ENGINEERING RECORD
DRAWINGS

WALDEN PRESERVE 2
Filing No. 4
Construction Drawings
El Paso County, Colorado

WALDEN PRESERVE 2
Filing No. 4
Grading & Erosion
Control Plans
El Paso County, Colorado

SITE GRADING AND EROSION CONTROL PLAN

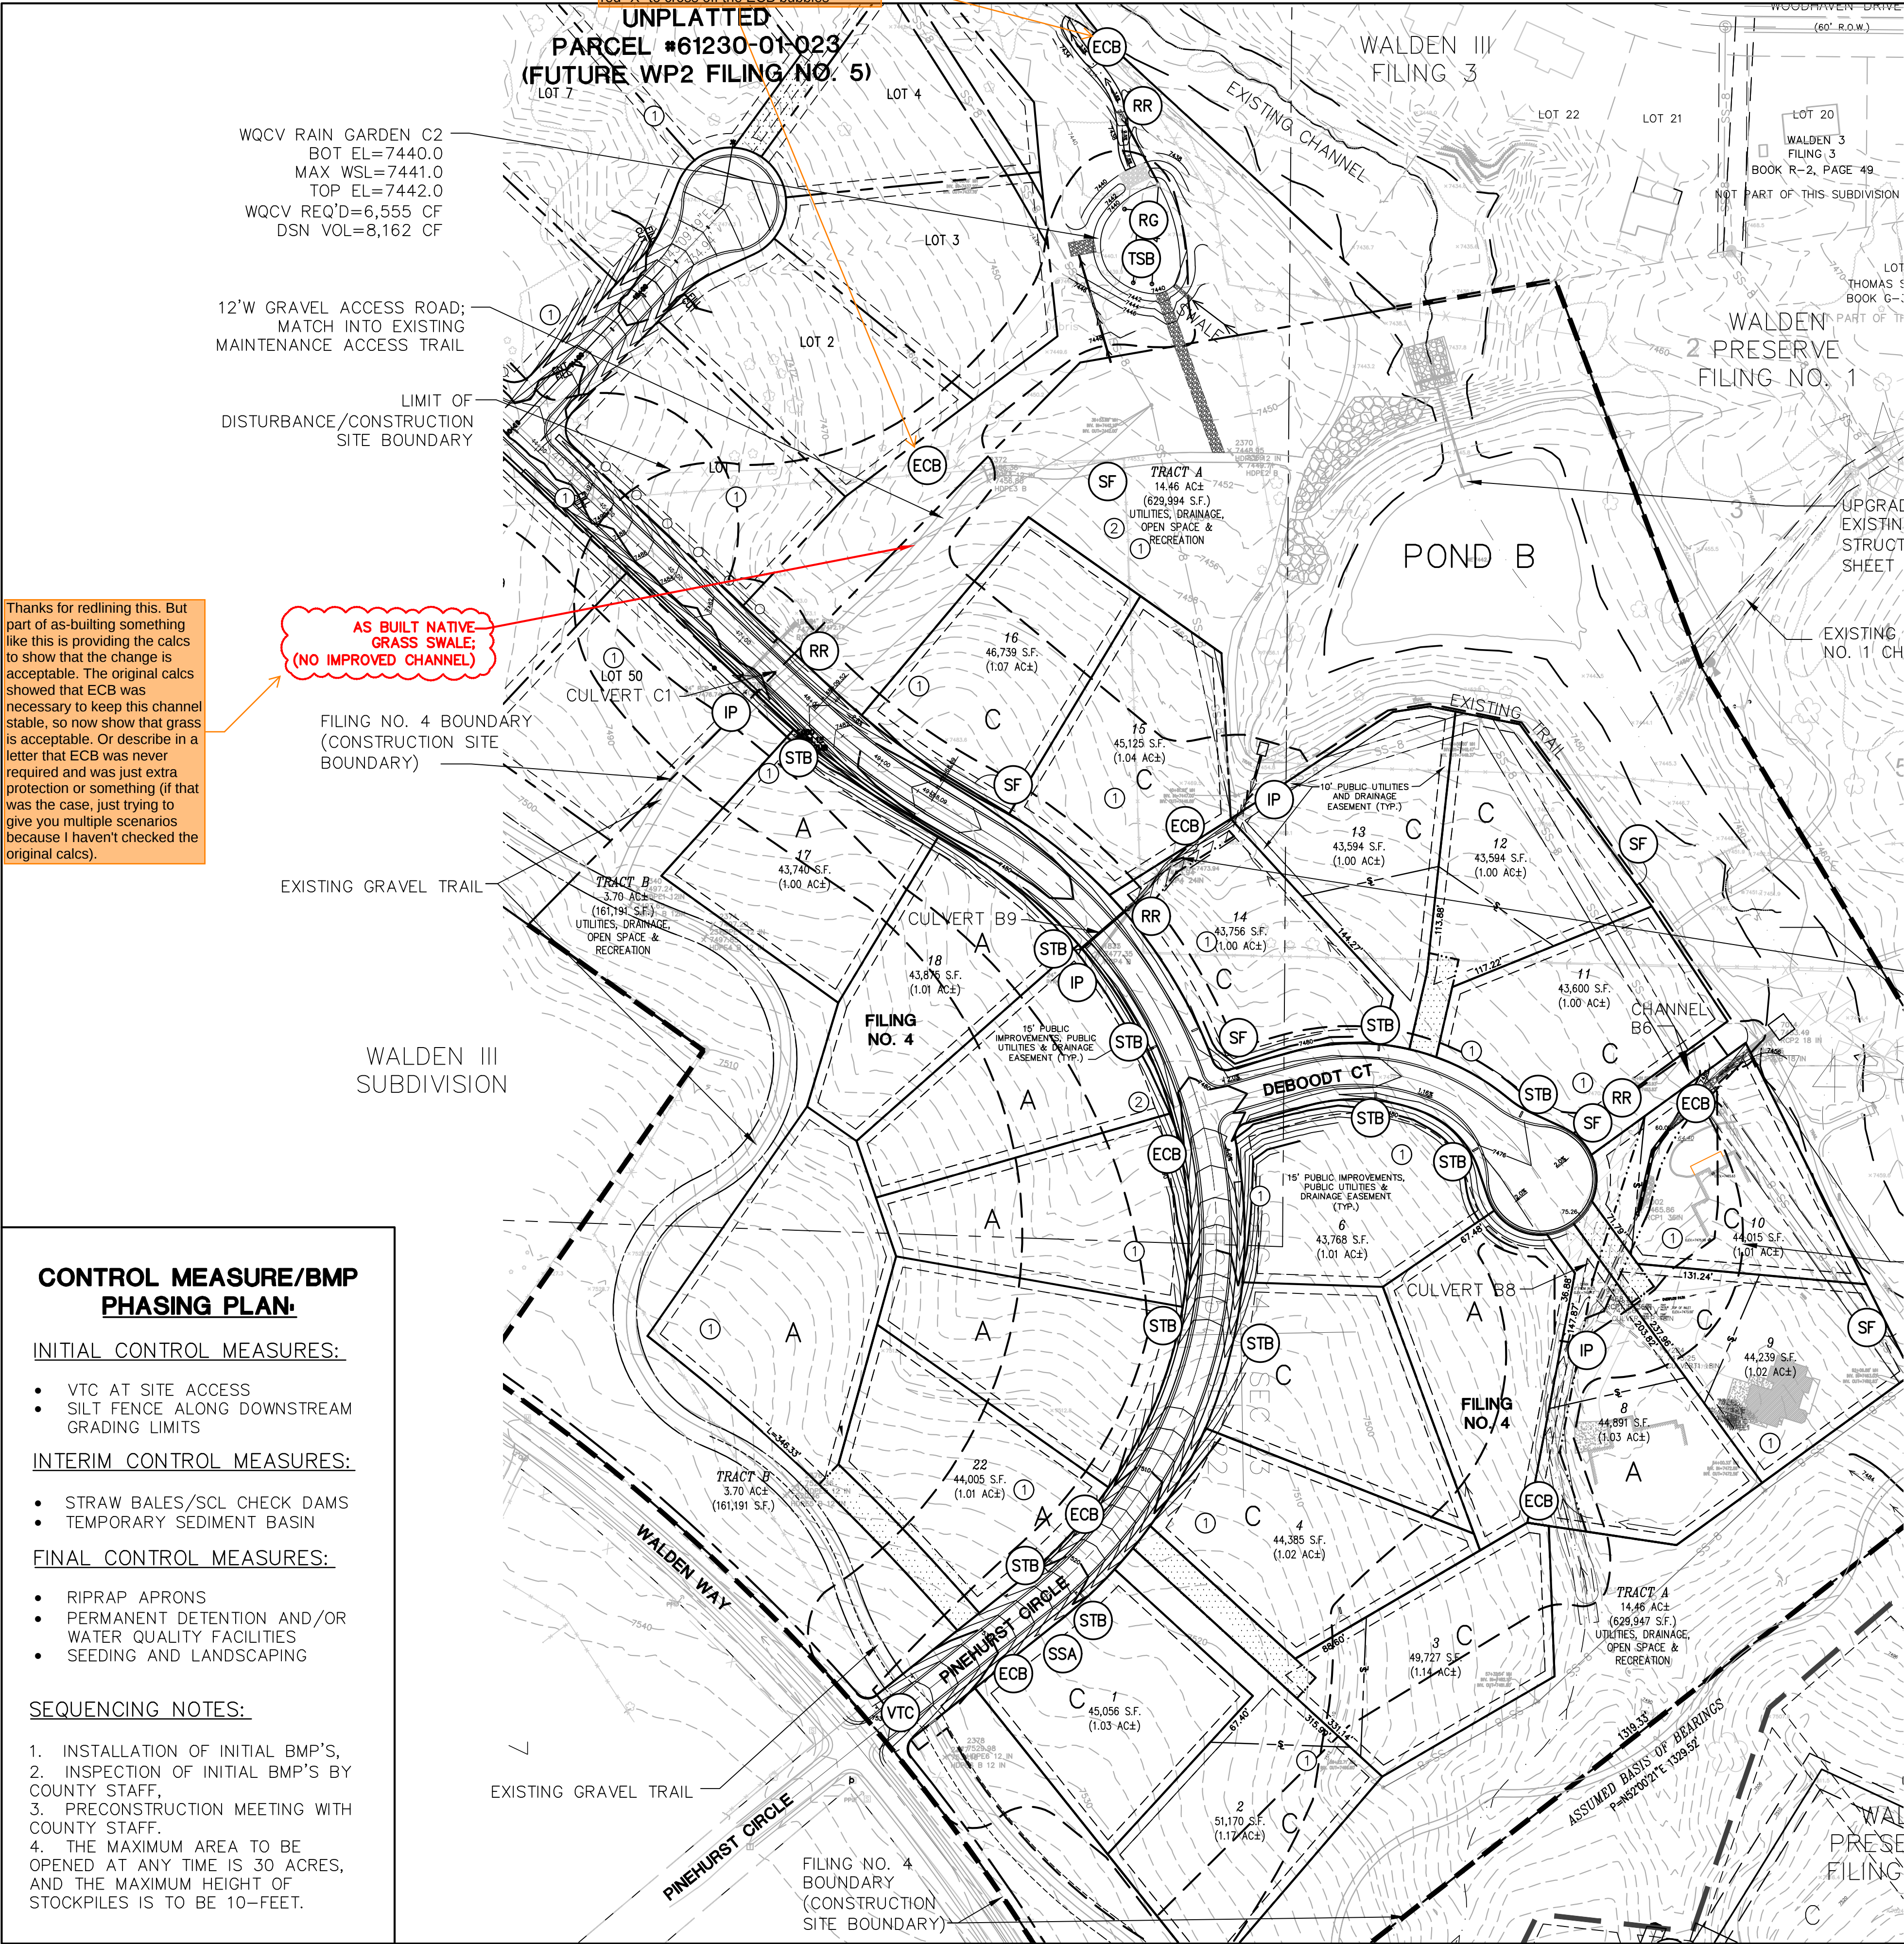
If ECB wasn't installed (you have removed the hatching since the last submittal), use a red "X" to cross off the ECB bubbles

The signature block for Engineering Record Drawings that was here with the last submittal was removed. Please add it back.

Thanks for redlining this. But part of as-building something like this is providing the calcs to show that the change is acceptable. The original calcs showed that ECB was necessary to keep this channel stable, so now show that grass is acceptable. Or describe in a letter that ECB was never required and was just extra protection or something (if that was the case, just trying to give you multiple scenarios because I haven't checked the original calcs).

ENLARGED SITE GRADING PLAN - SOUTH

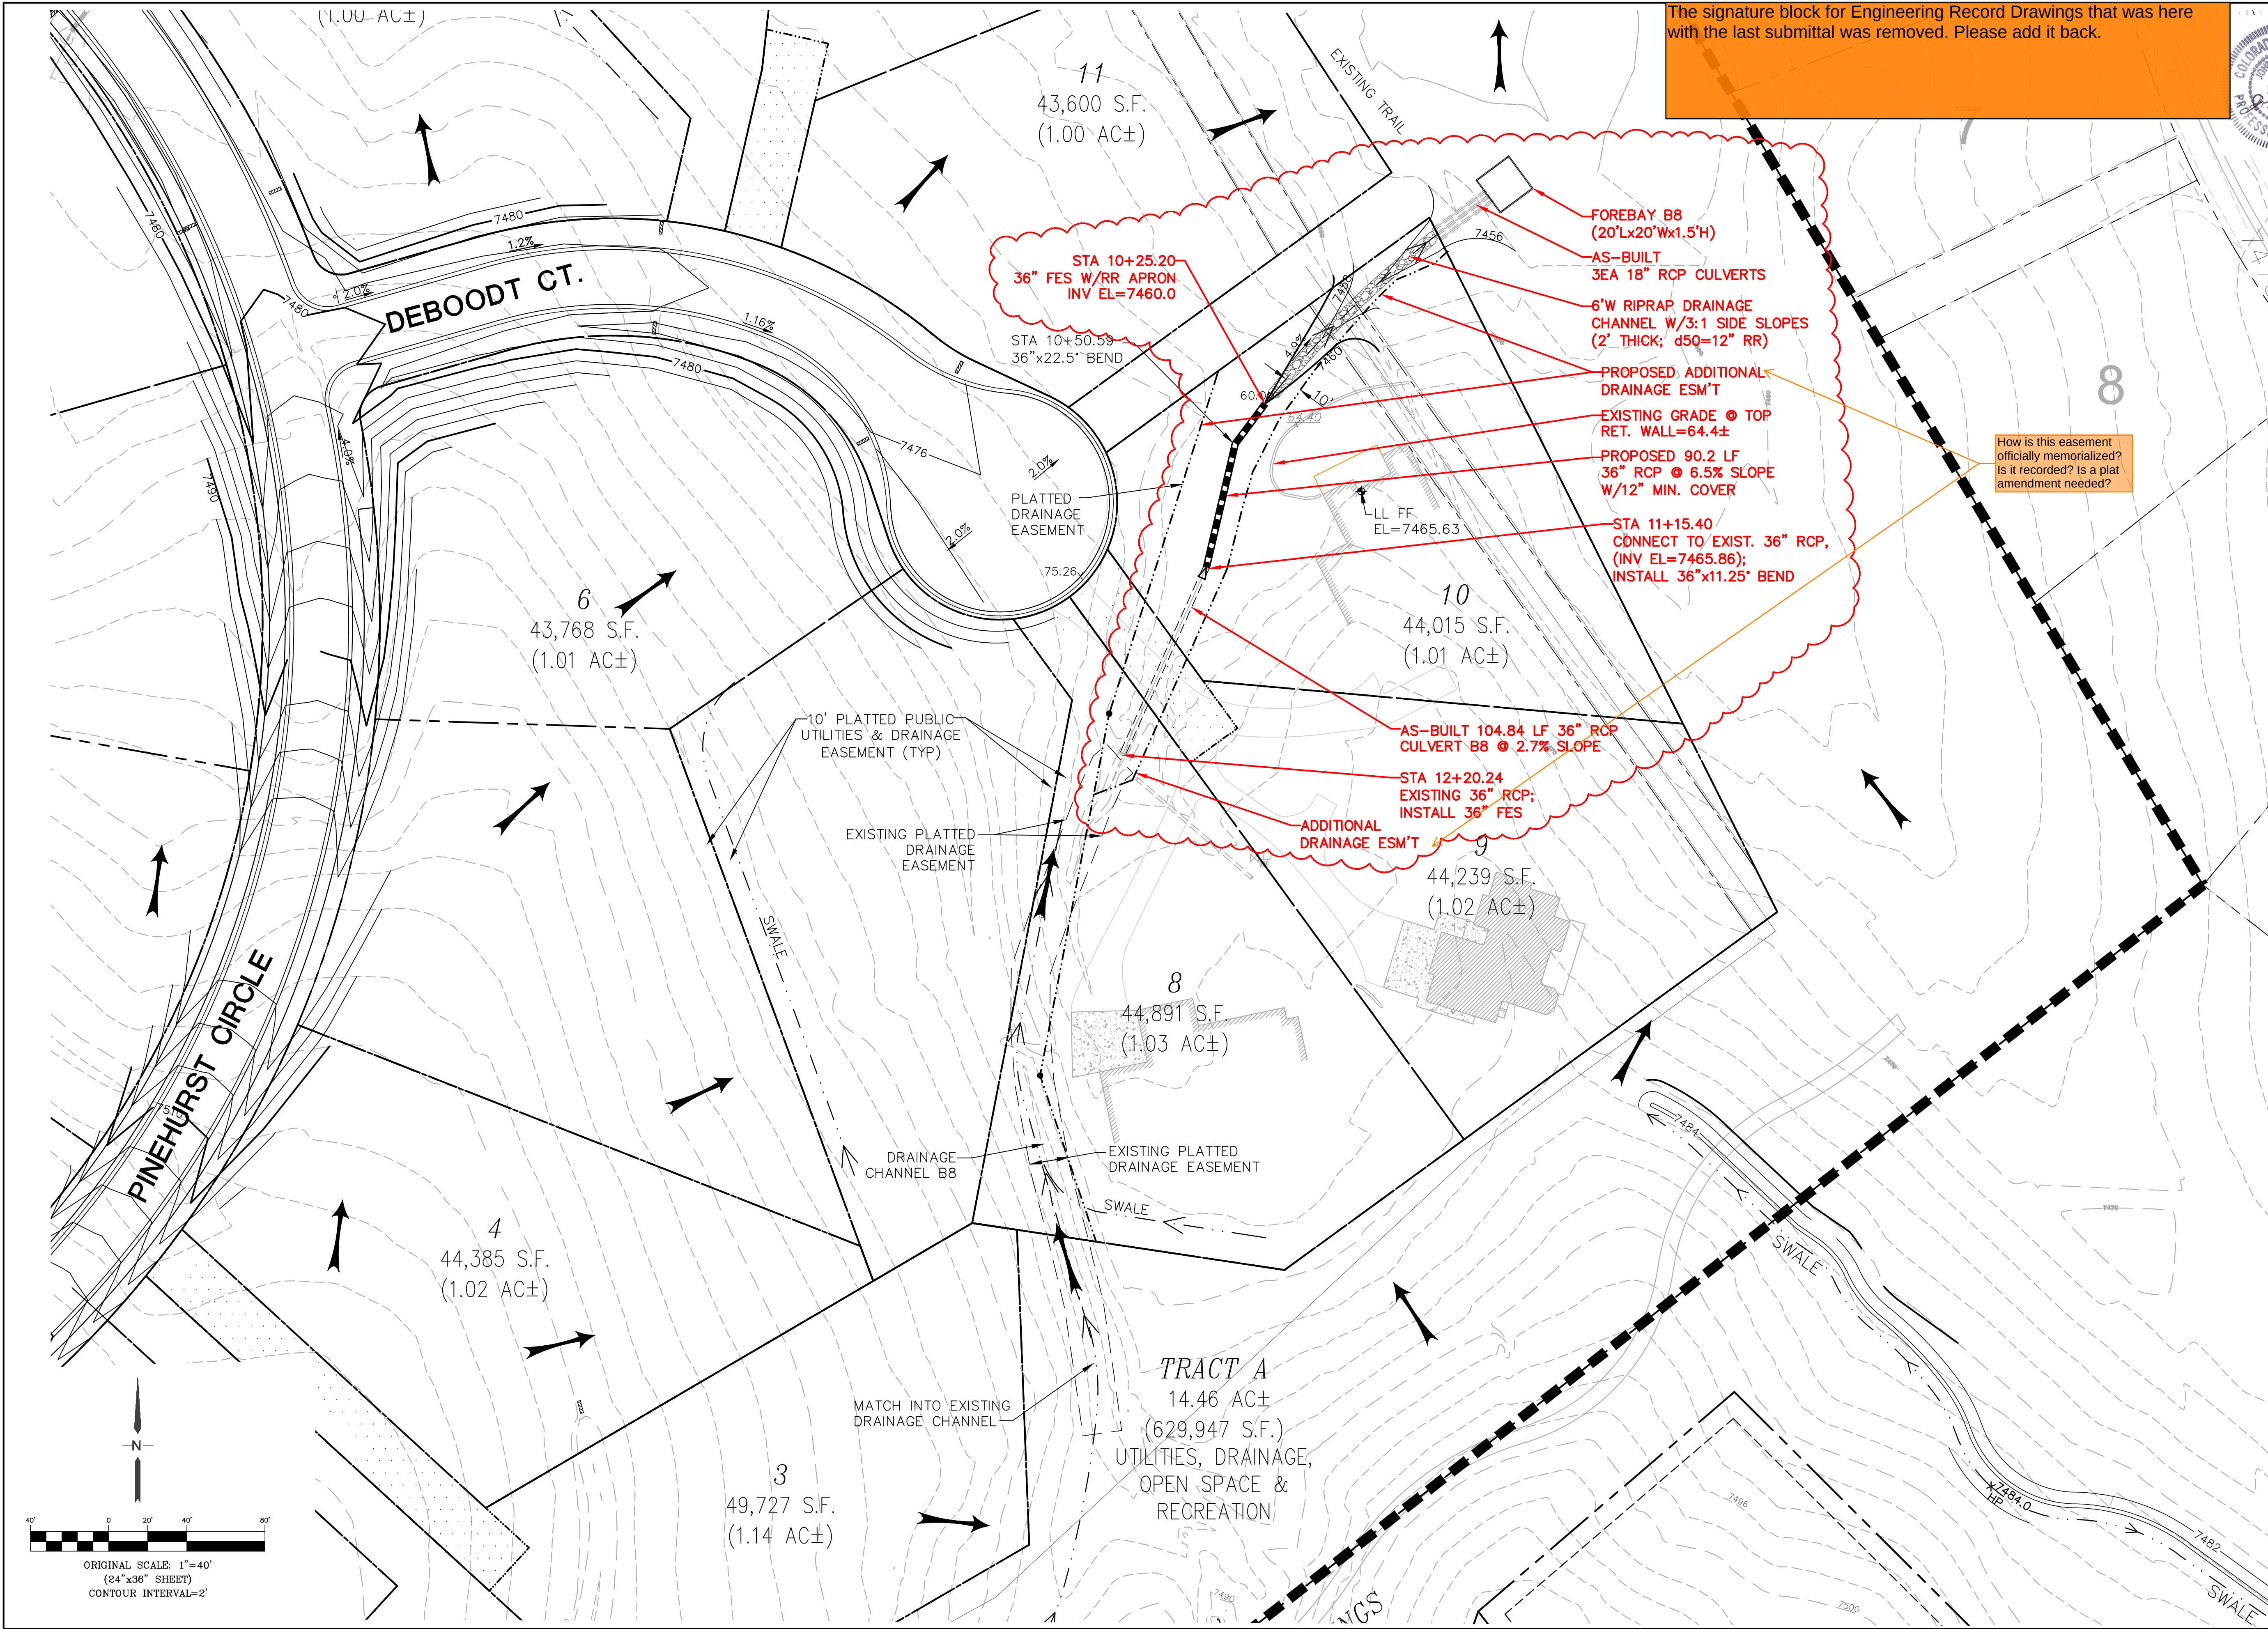
The signature block for Engineering Record Drawings that was here with the last submittal was removed. Please add it back.

ENLARGED SITE
GRADING PLAN - NORTH

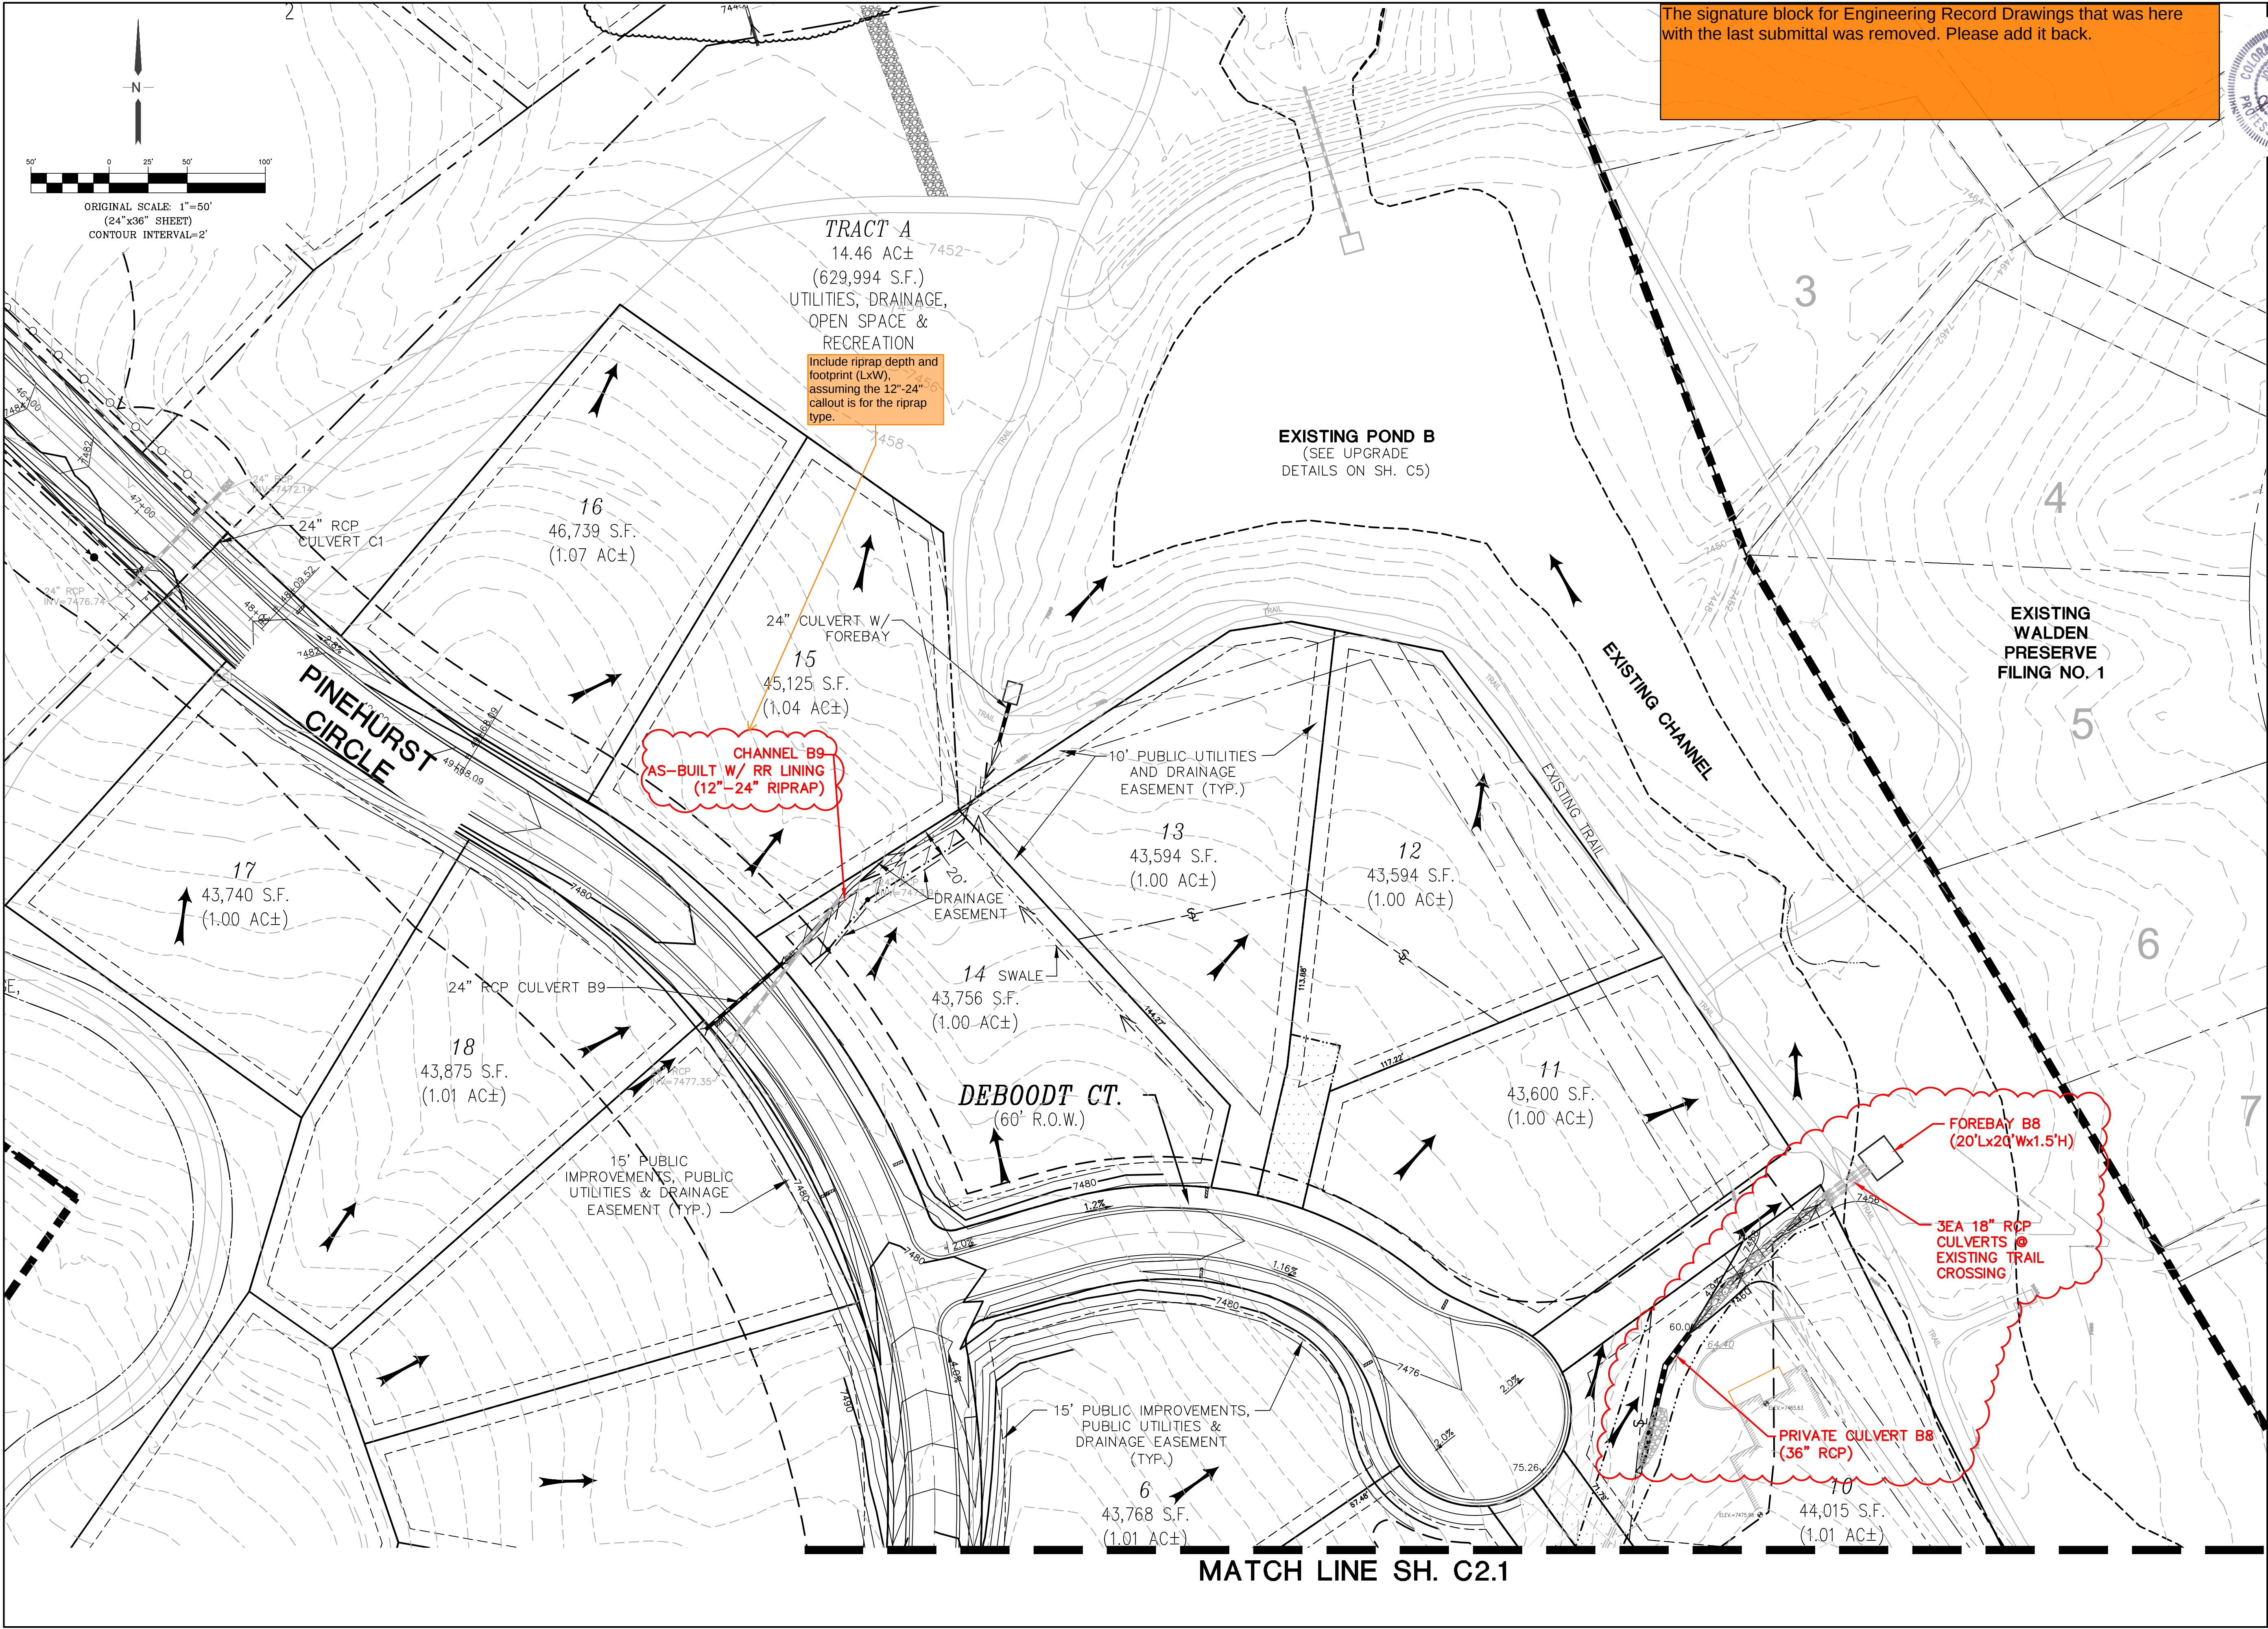
The signature block for Engineering Record Drawings that was here with the last submittal was removed. Please add it back.
